Application No. 10/643,807 Amdt. dated March 17, 2005 Reply to Office Action dated November 17, 2004

Amendments to the Drawings:

FIG !

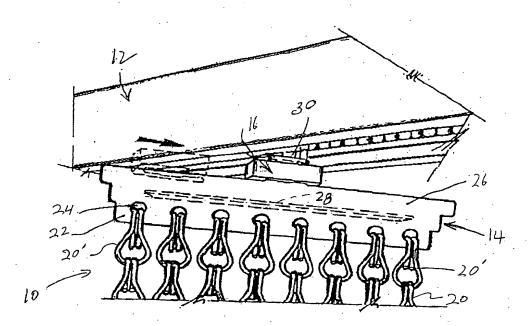
Mainerals to Fiz 2 30 140 28 28 14

Ramone lead lines Som FIG 16
